DD1 LTC2208

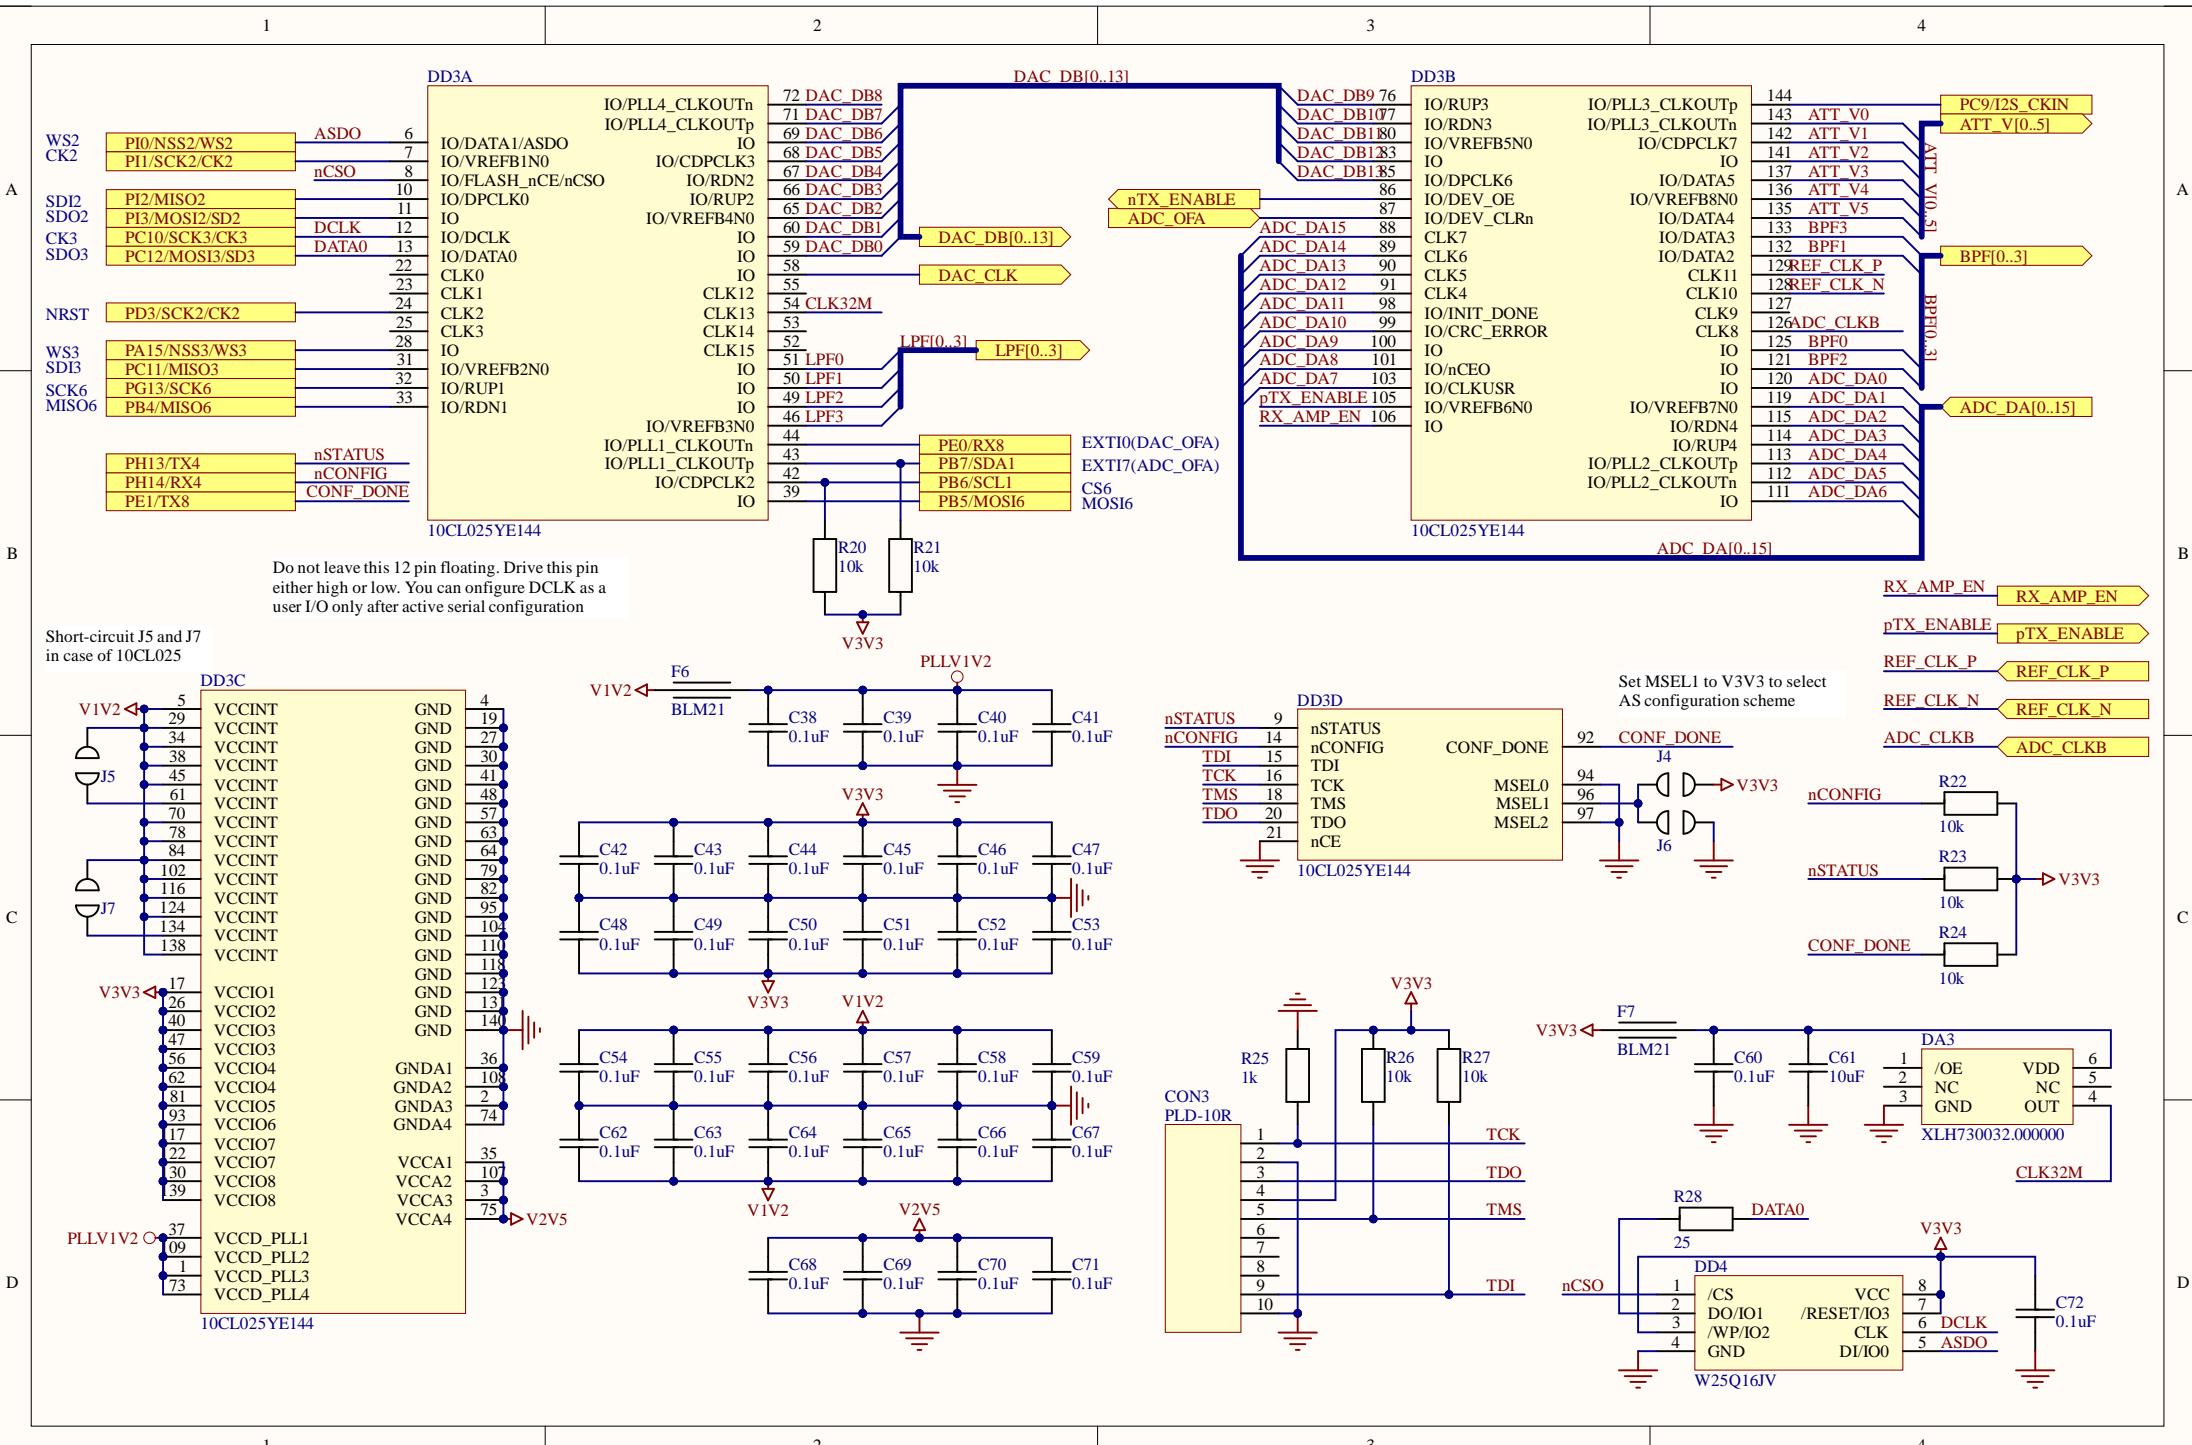
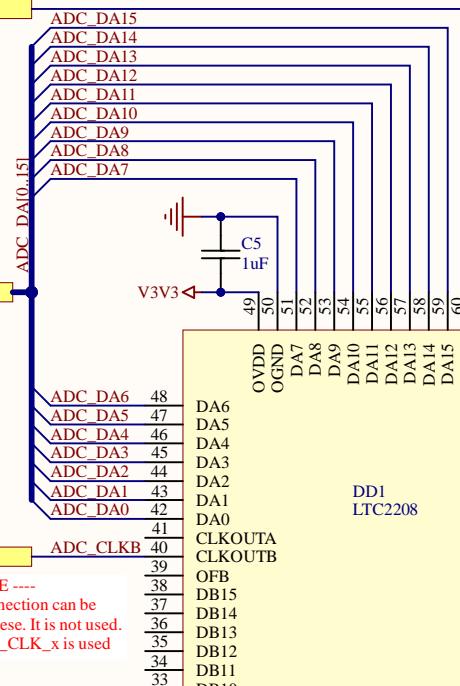
ADC_CLKB
--- TO IMPROVE ---
ADC_CLKB connection can be deleted in next release. It is not used.
Instead diff REF_CLK_x is used

--- TO IMPROVE ---
Add jumpers in order to allow Randomizer selection in next releases

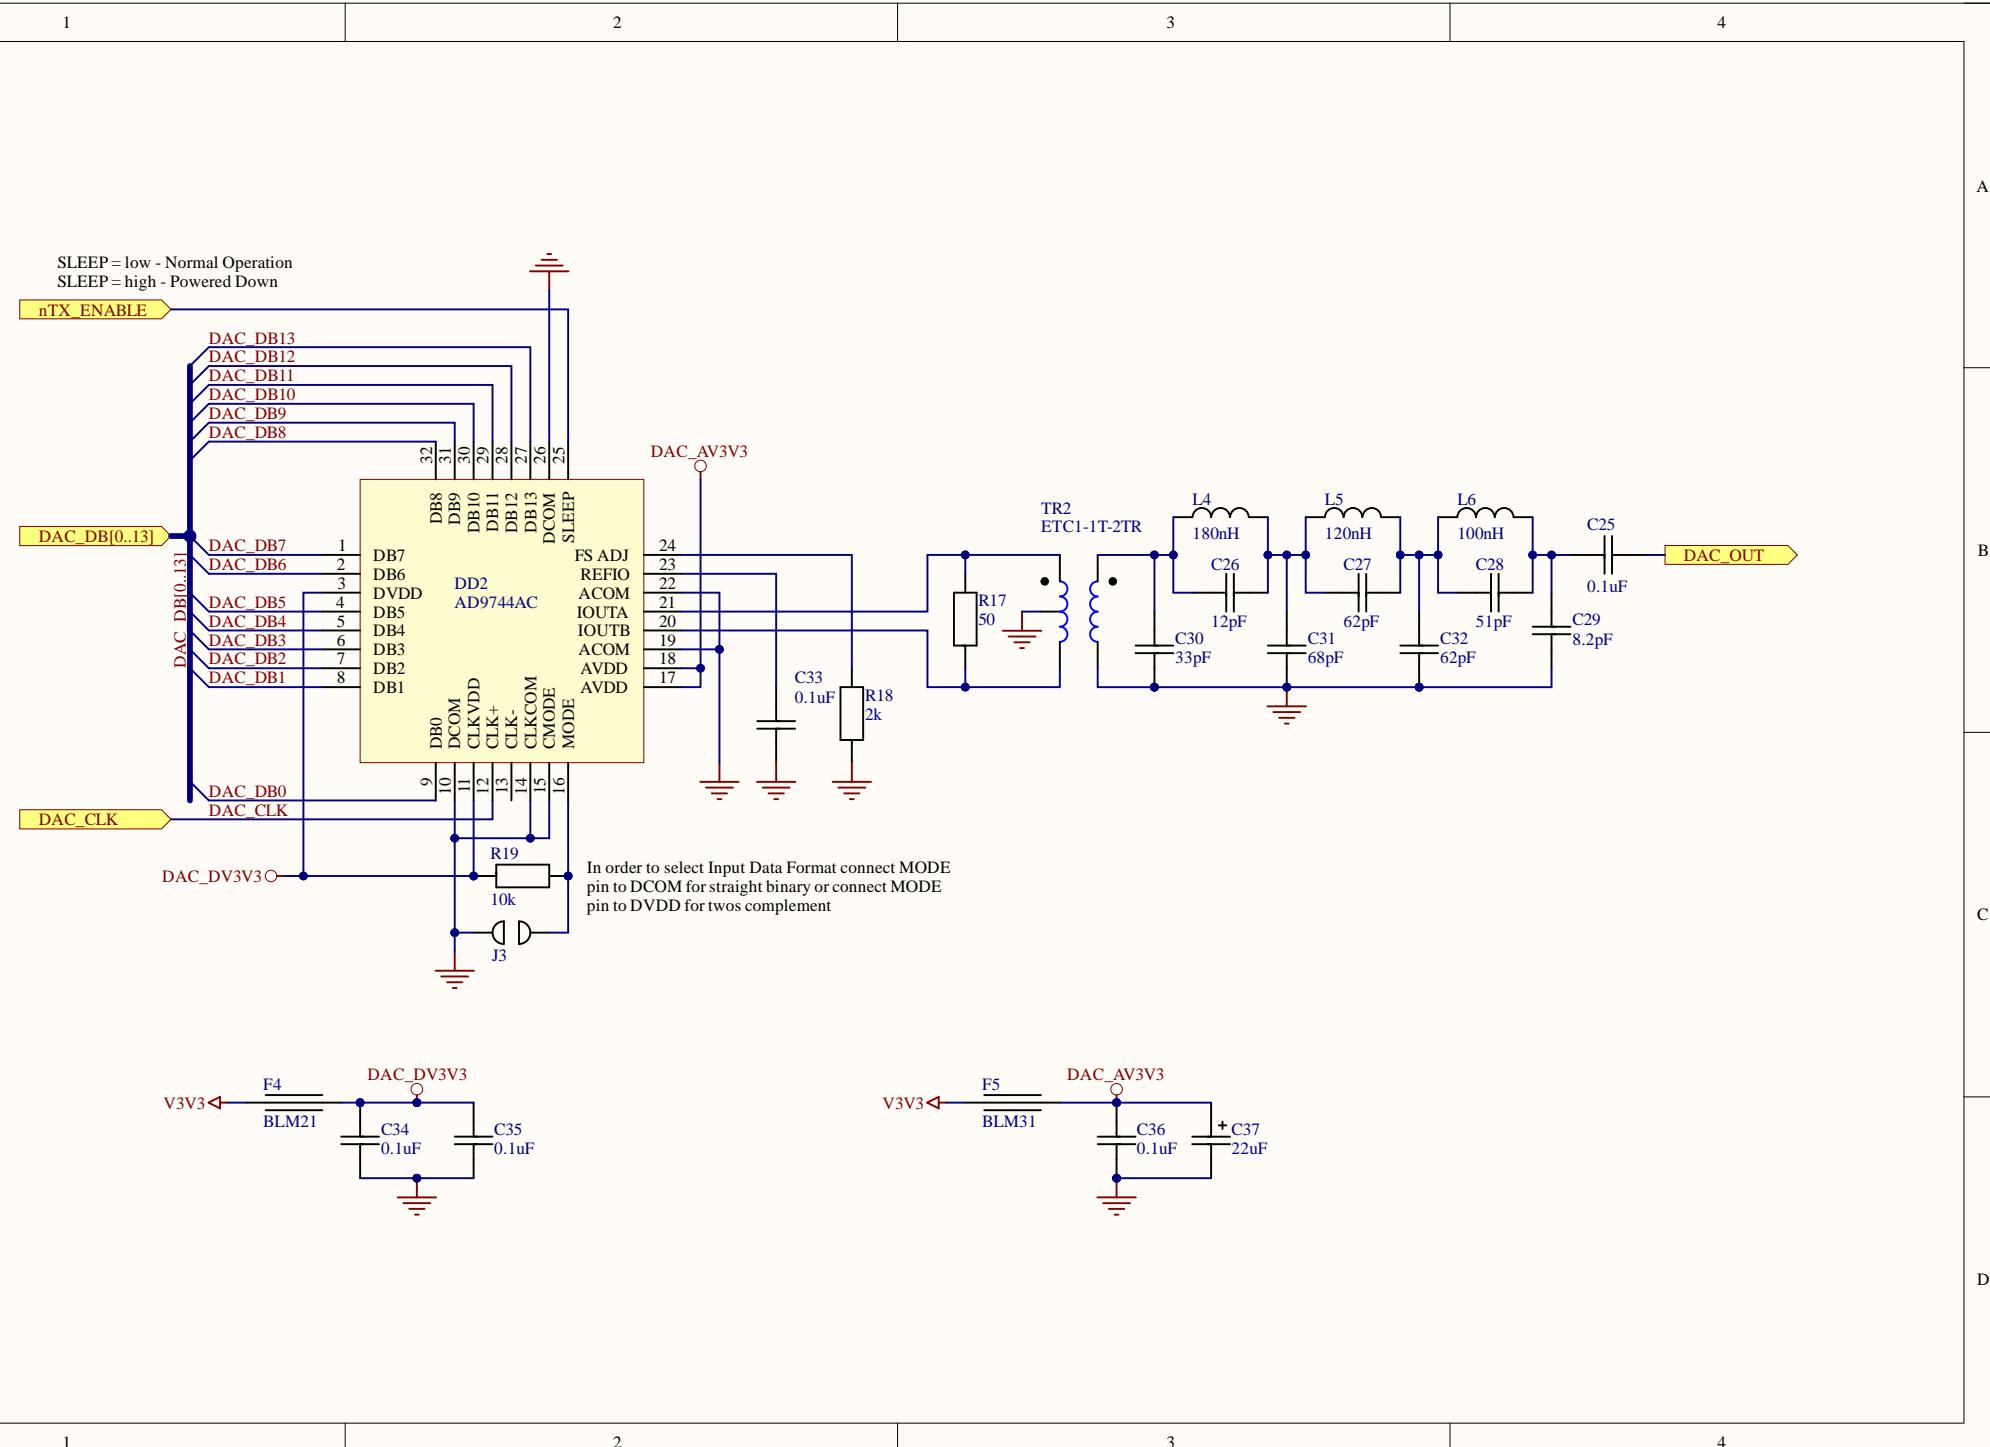
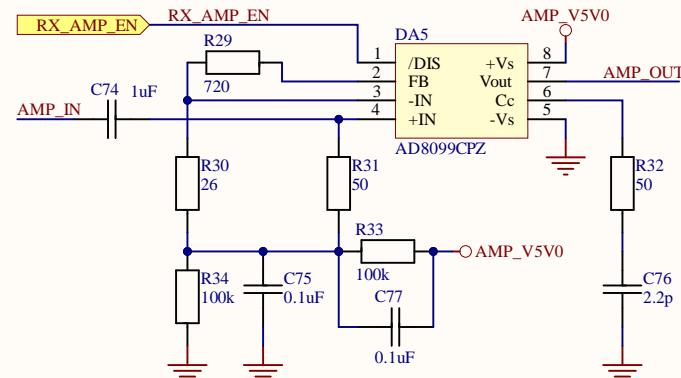
---- TO IMPROVE ----
 /DIS pin should be unconnected to reduce noise (see datasheet). Use transistor to power on/off DA5
